ST. JOHN'S CHURCH LINCOLN

ST. JOHN'S Church LINCOLN

FIRST DESIGN REJECTED

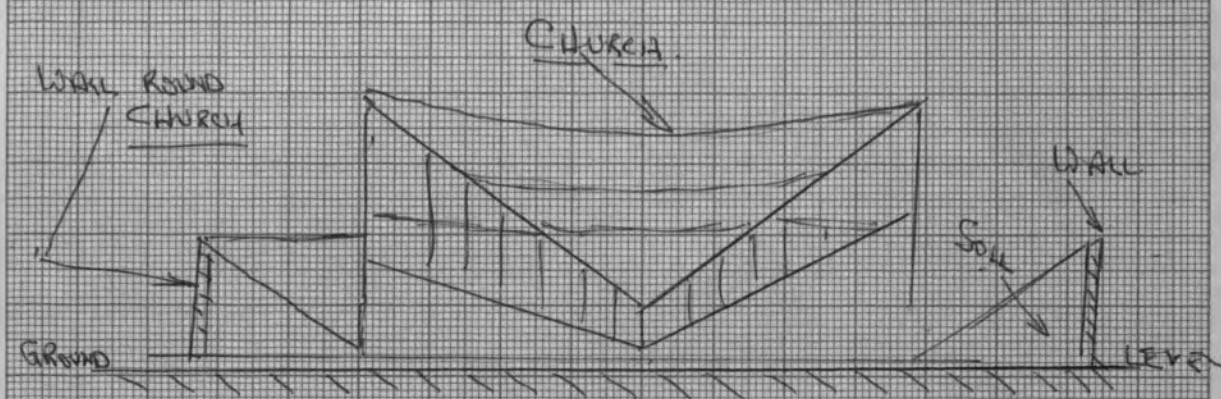
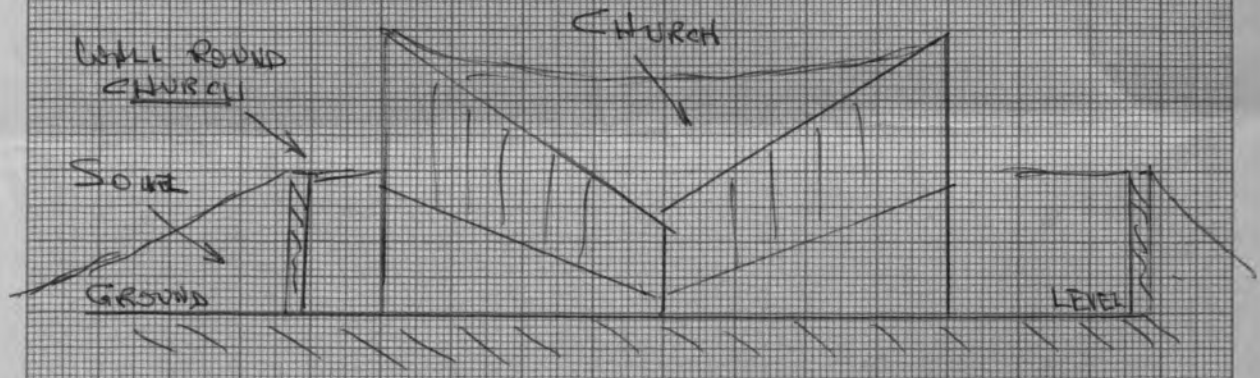
The above outside designs were rejected by the P.C.C., the 3rd design, owing to cash shortage started with wooden fence and at a later date a small brick wall.
